| Safety Recall Campaign | 2016-2018MY K900(KH) |
| SC227A | April 2022 |

HECU FUSE REPLACEMENT (SC227A)

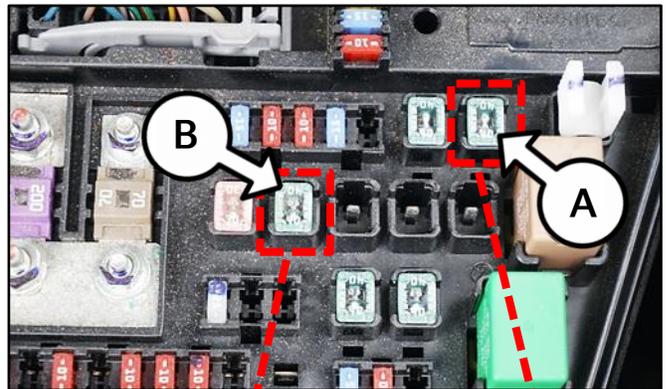
- 3a. Remove two (2) 40A fuses (A) and (B).
- 3b. Install the new amperage fuses as follows:

- A. ESC1 fuse → new 20A
- B. ESC2 fuse → new 25A

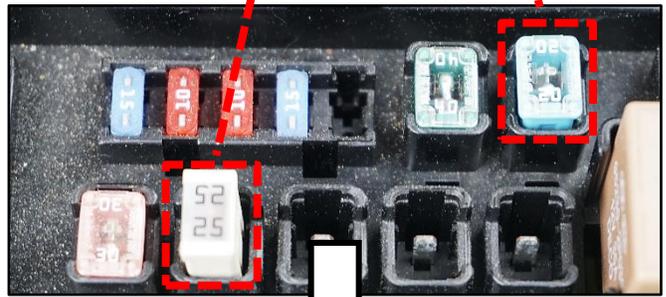
Ensure to replace ESC1 fuse (A) with the 20A fuse and ESC2 fuse (B) with the 25A fuse.

5. Adhere the new ESC1 20A and ESC2 25A labels to the bottom of the junction box fuse cover as shown.
